Written Testimony of James Wells, PhD, Environmental Geologist
L. Everett & Associates, Environmental Consultants
Testimony before House Natural Resources Subcommittee on
Indigenous Peoples of the United States
Hearing on “The Irreparable Environmental and Cultural Impacts
of the Proposed Resolution Copper Mining Operation”
March 12, 2020

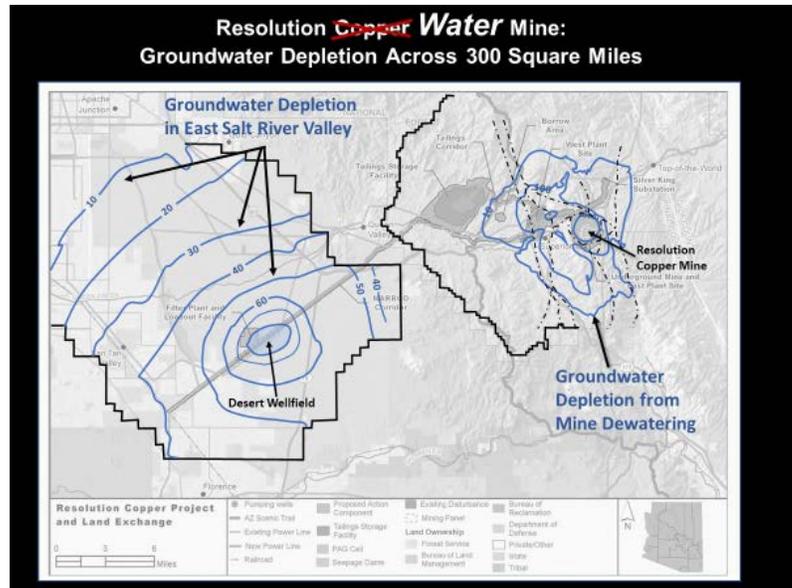
Resolution's own assessment acknowledges that groundwater will be depleted by at least 10 feet (and in some places, more than 1,000 feet) over an area covering about 300 square miles. As shown on this map, this is a consequence of dewatering at the mine site as well as massive amounts of pumping that will occur in the East Salt River Valley, about 15 miles west of the mine. No one knows how long it will take for the aquifers to recover after the mine closes, but Resolution once estimated that it would take about 1,000 years.
